Work Order ID 93130

Item Name: Mounting Lug

DRAWING NO. D2731	TITLE MOUNTING LUG	REV. C	DART AEROSPACE USA, INC ENGINEERING ORDER		D.E.O. NO. D2731-C-1	SHEET NO. SHEET 1 OF 1	SCALE NTS
DRAWN <i>q</i>	CHECKED <i>sc</i>	MFG. APPR. <i>M</i>		APPROVED <i>MD</i>	DE APPR. <i>MD</i>		
DATE 11.05.02	DATE 11.05.09	DATE 11.05.09		DATE 11.05.09	DATE 11.05.09

ADD D2731-xRG OPTION

D2731-1RG MOUNTING LUG (SHOWN)
D2731-3RG/-5RG/-7RG MOUNTING LUGS (SIMILAR)

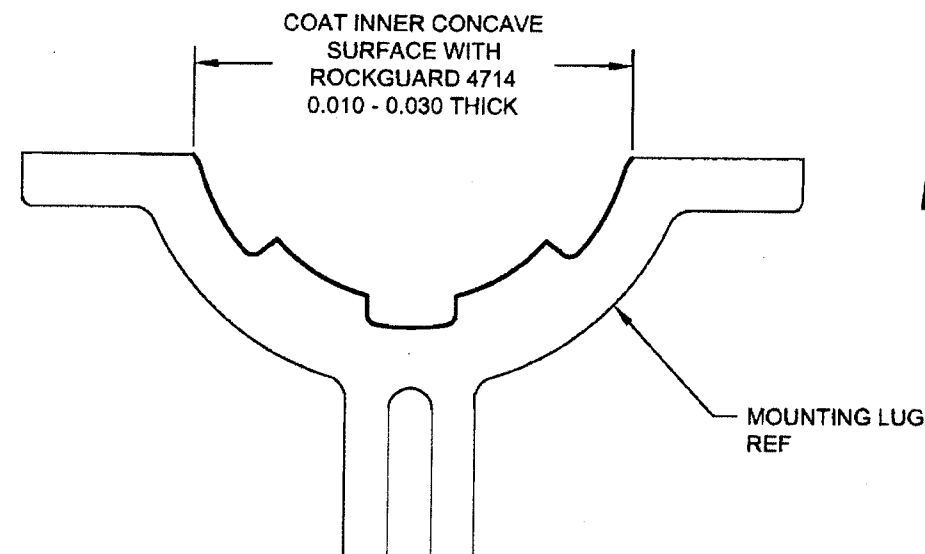
D2731-xRG MOUNTING LUGS ARE INDENTICAL TO D2731-x MOUNTING LUGS, HOWEVER AFTER FINISH, COAT INNER CONCAVE SURFACE WITH "PLUS ONE ROCKGUARD 4714" AS SHOWN BELOW.
